Project	IEEE 802.16 Broadband Wireless Access Working Group http://ieee802.org/16 >	
Title	STTD mapping for UL 2-antenna MIMO transmissions	
Date Submitted	2005-01-13	
Source:	Jia, Mo-Han Fong, Hang Zhang, Brian Johnson	Voice: (613)-765-8089 Fax: (613)-765-7723 pyzhu@nortelnetworks.com
Re:	Call for Reply Comments regarding the Maintenance Task Group Comment Report 80216maint- 04 09.zip	
Abstract	In this contribution, we propose to clarify the STTD mapping for UL 2-antenna MIMO transmission	
Purpose	The contribution should be considered by Maintenance group within comment resolution procedure	
Notice	This document has been prepared to assist IEEE 802.16. It is offered as a basis for discussion and is not binding on the contributing individual(s) or organization(s). The material in this document is subject to change in form and content after further study. The contributor(s) reserve(s) the right to add, amend or withdraw material contained herein.

STTD mapping for UL 2-antenna MIMO transmissions

Figure 249b –UL STC Tile

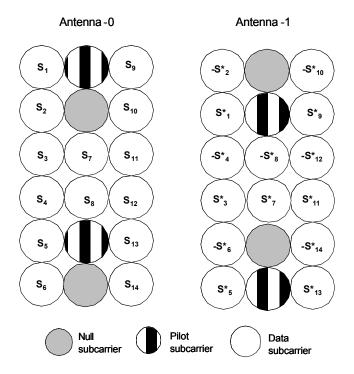
1 Proposed to	ext change	
Change text in section		
diversity data or 2-trans	mission using STC configuration smit spatial multiplexing data can nodate those configurations. Figur	in the uplink, shall use a modified uplink tile, 2-transmit be mapped onto each subcarrier, The mandatory tile shall e 249a depicts the UL title for STC transmission and
Change Figure 249 in Start Text		
	Antenna-0	Antenna-1
	S ₀ S ₁ S ₂ S ₃ S ₄ S ₅ S ₆ S ₇ Null subcarrier	Pilot Subcarrier Data Subcarrier
		a –UL STC tile
End Text		
		te STC configurations. Figure 249b depicts the UL optiona
End Text		
Insert the Figure 249b	in section 8.4.8.1.5
